Robin Partington & Partners  
built around people

# Parker House Additional Balconies Justification

Proposed Third Floor Plan

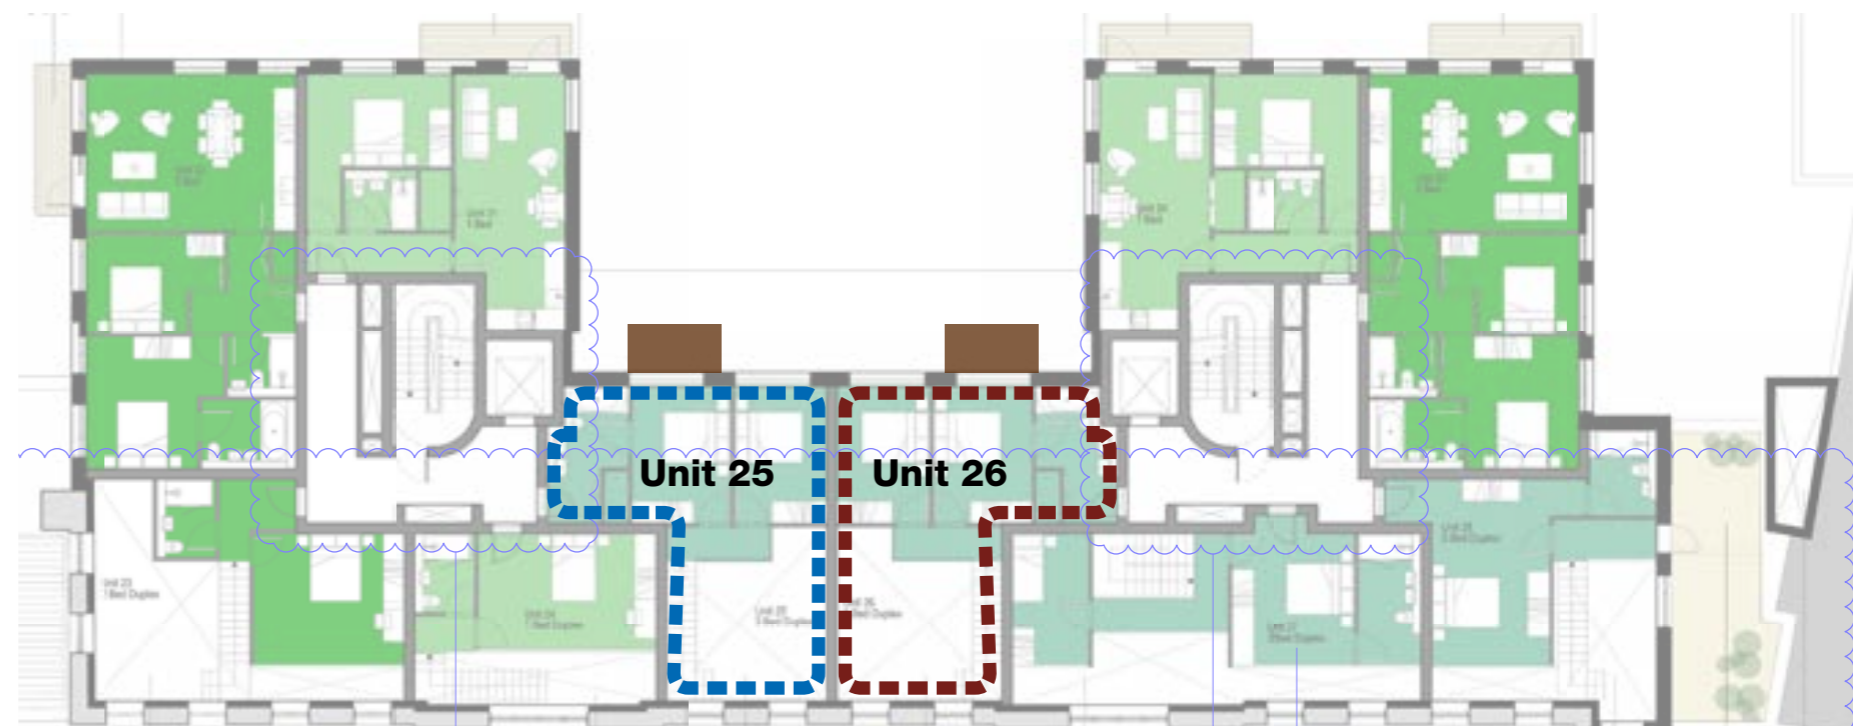
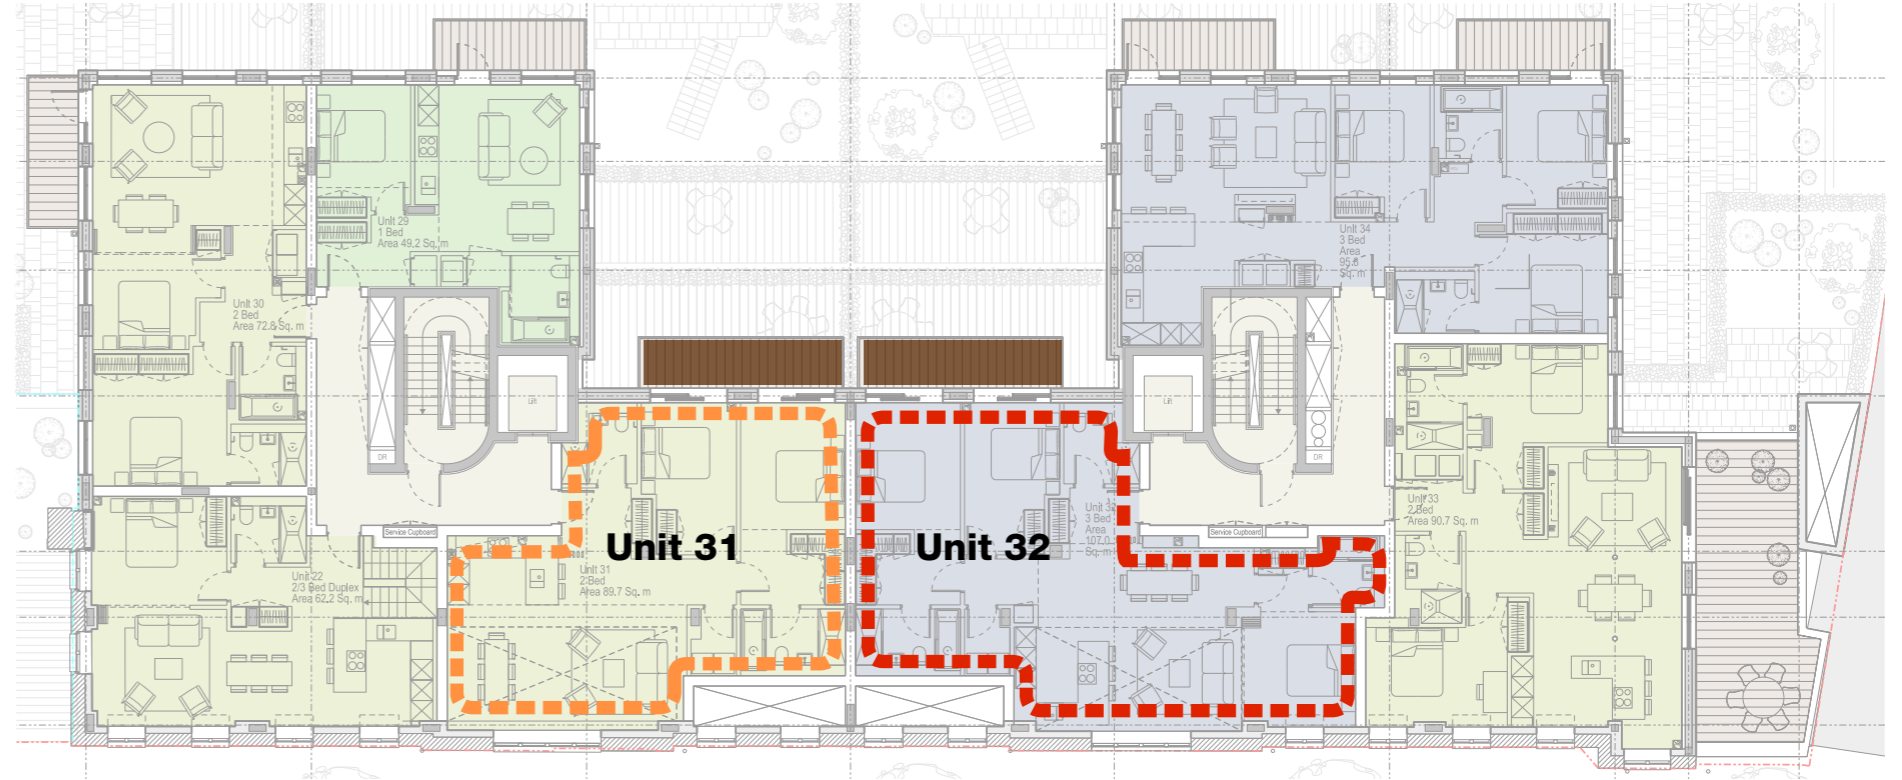
The design development of the layouts has reduced the number of duplex units, in order to maximise the use of space. What has previously been 2 duplex units on the 2nd and 3rd floor at the middle of the development, has therefore become 4 separate, single level units.

Following the strategy to implement private external amenity space where ever possible within the consented scheme, the proposal includes two additional balconies on the third floor for units 31 and 32.

Proposed Third Floor Plan

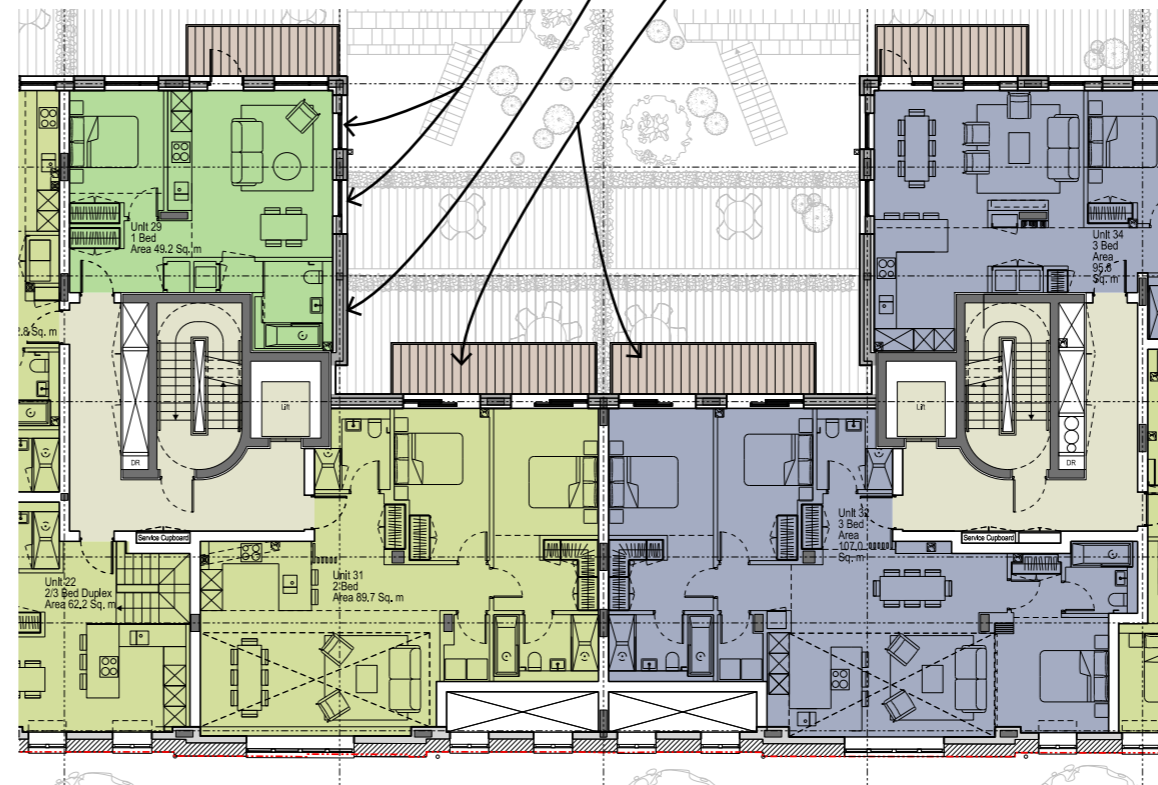
In order to mitigate a loss of privacy on the adjacent units by adding the two additional balconies to the third floor, to measures described on the right hand side have been implemented.

Each window has 1/3 covered with a 'blanking panel' to reduce visual proximity to adjacent units.

Fenestration is only within the half of the flank elevation farthest from adjacent units.

Proposed additional balconies.
